DATE	REVISION
22 AUG 25	ADDENDUM 1 RE-ISSUE DECK, COLUMN, ROOF AND MECH ROOM REVISIONS
23 OCT 23	LANDSCAPE WALL AND FRAMING REVISIONS
7 SEP 22	FRAMING REVISIONS
24 JUN 22

A Townhouse Development for
Walton Cr Rd / Village Dr
 1805 Walton Creek Road, Steamboat Springs, Colorado 80487

**NORTH BUILDING
LOWER ROOF AND ROOF DECK
FRAMING PLAN**
Scale : 1/4" = 1'-0"

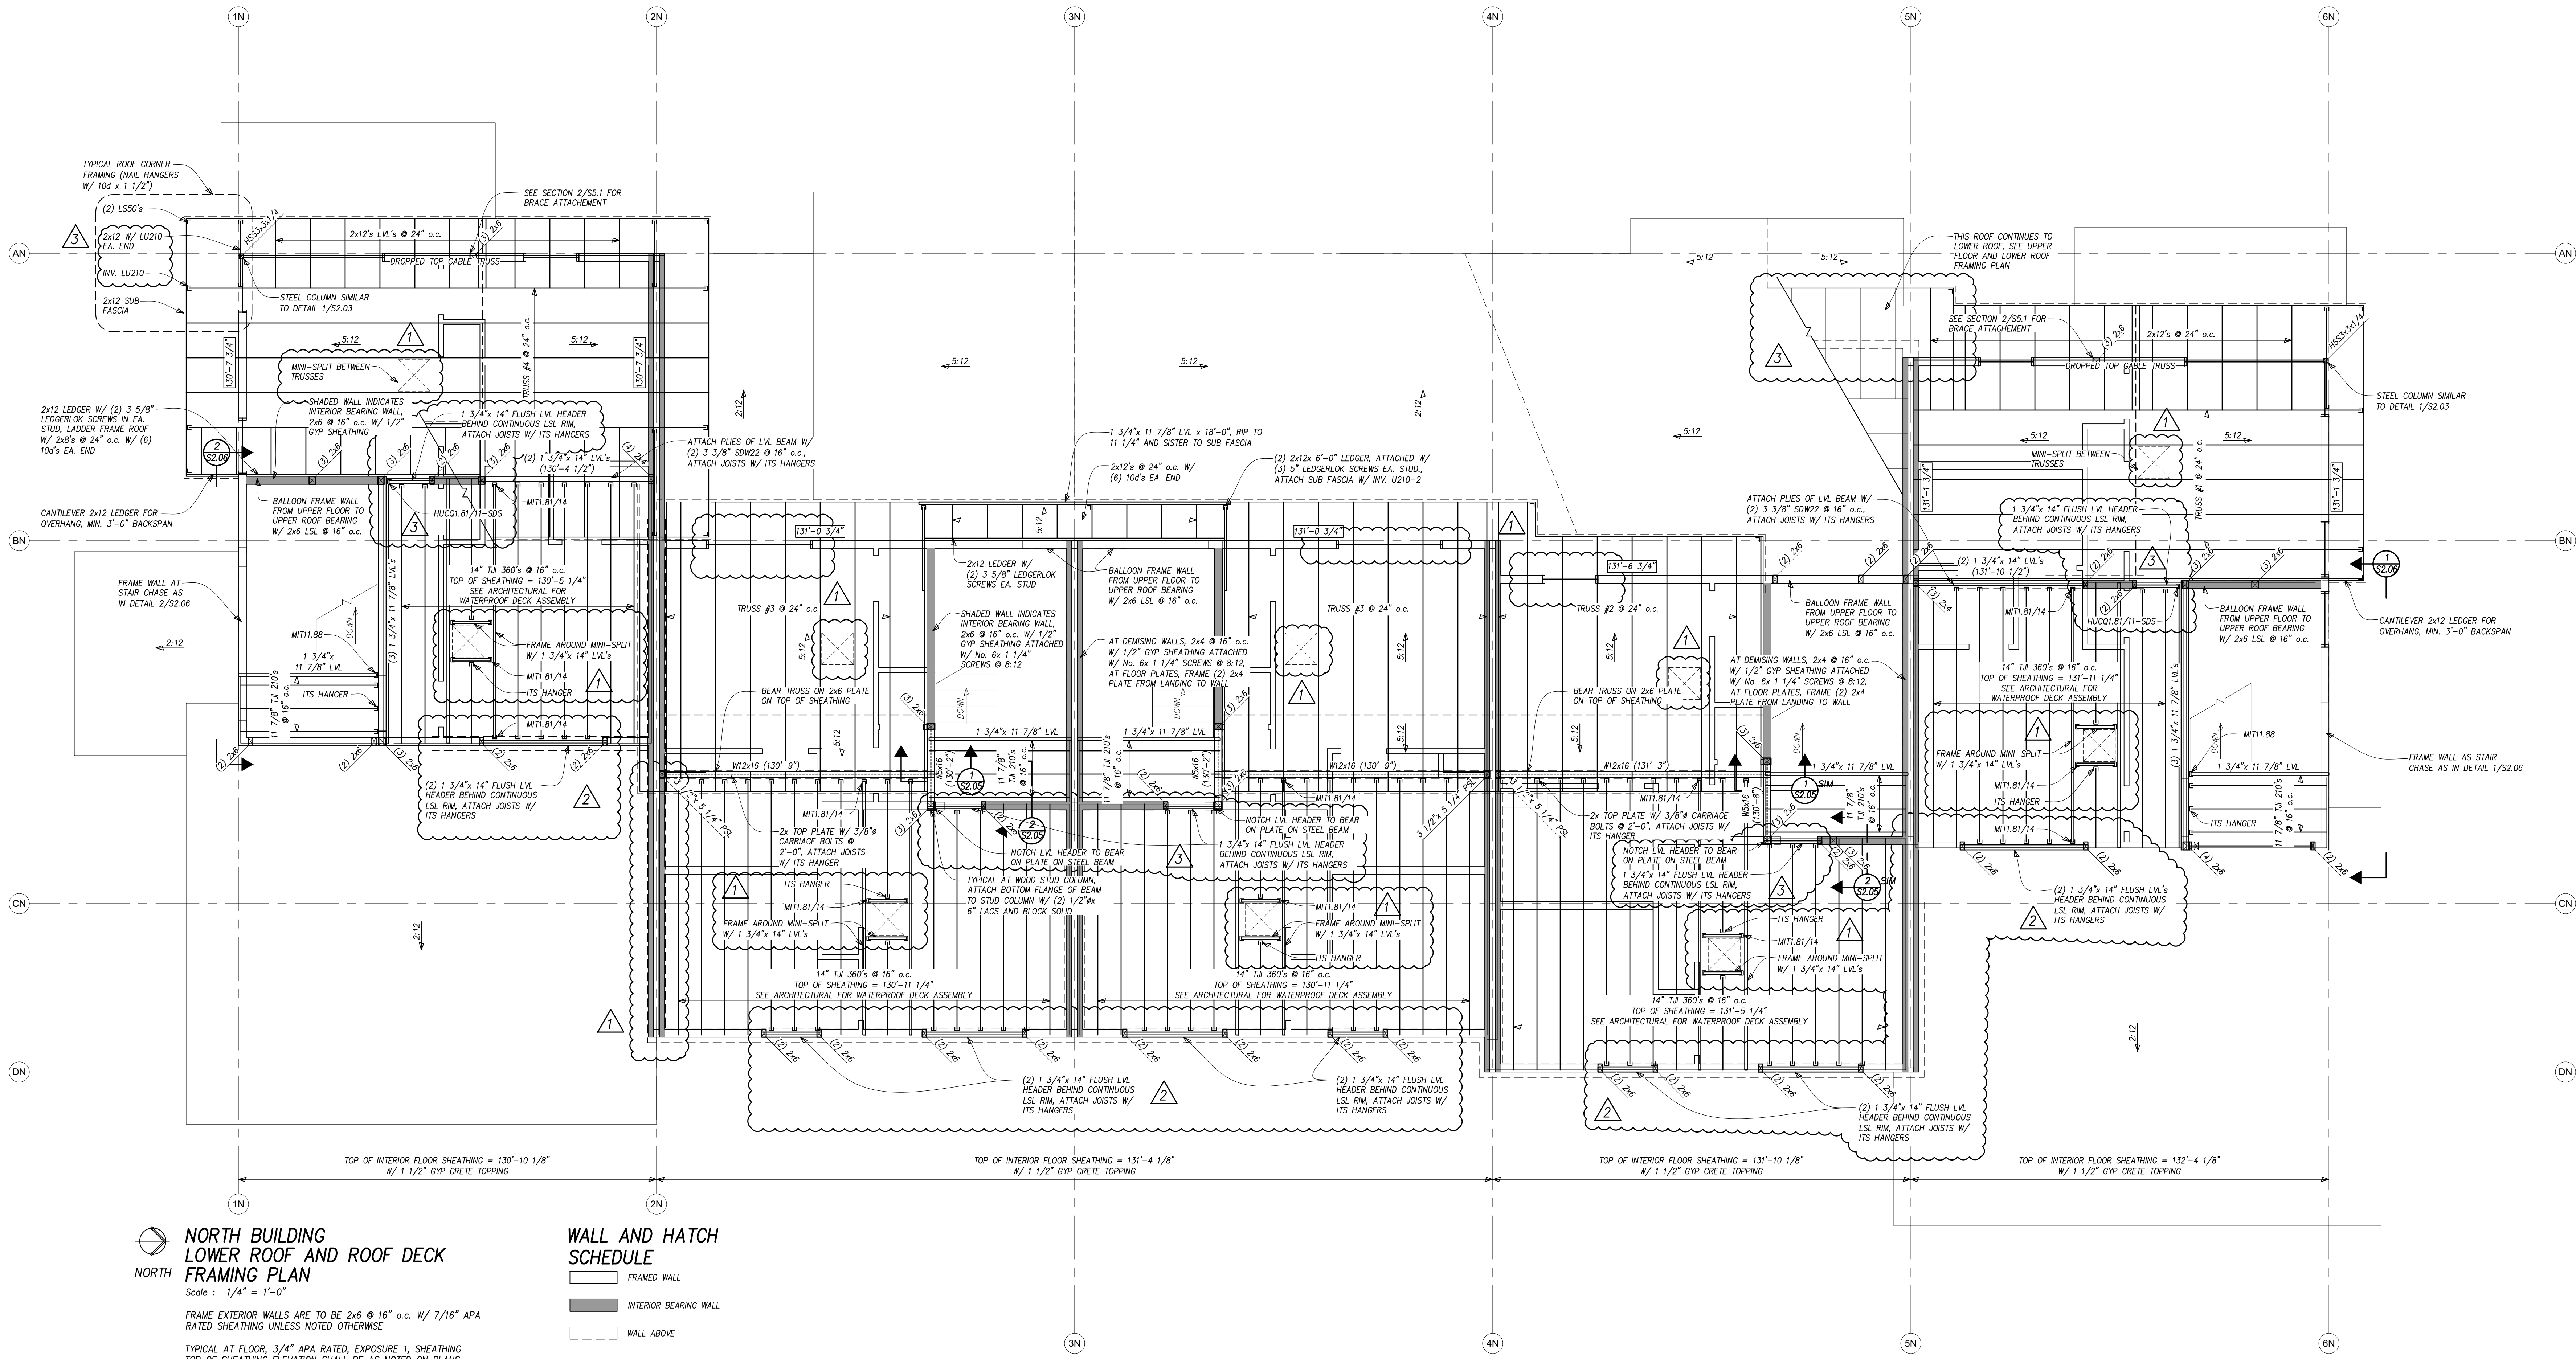
BEAR JOISTS ON 2x6
PLATE ON W5x16

W5x16, SEE PLAN, W/ WEB
STIFFENER FROM 1/4"
PLATE, (2) SIDES, (2)
LOCATIONS

COPE FLANGE AND WEB OF W12x16;
WELD NEW 1/2"x4"x5" PLATE TO
WEB, BEAR ON W5x16 AND ATTACH
W/ 1/4" FILLET WELD (2) SIDES

2x12 LEDGER, ATTACH TO
PLATE AND RIM W/ (2) 3 5/8"
LEDGERLOK SCREWS @ 16" o.c.

BEAR DECK JOISTS ON
INTERIOR BEARING WALL
